Specification Change of BVW-T

We would like to inform that we will change the specification of BVW-T as follows.

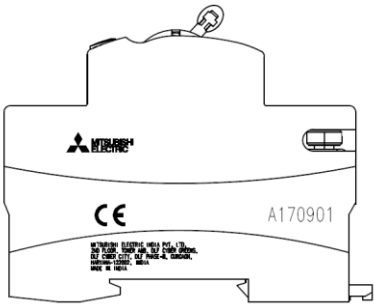
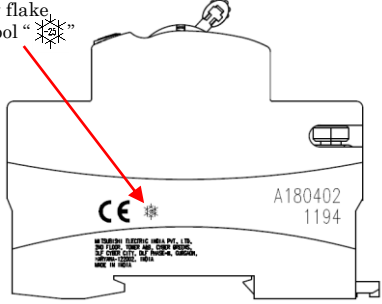
Item	Before change	After change
1)Rated conditional short-circuit current (Inc)	6kA	10kA
2)Ambient temperature range*	-10℃ to +40℃	-25℃ to +40℃
3)Indication		 Addition of Snow flake Symbol "❄"

- 1), 2): To improve performance
- 3): Because of requirement in EN 61008-1 for RCCBs use at ambient temperatures between -25℃ and +40℃
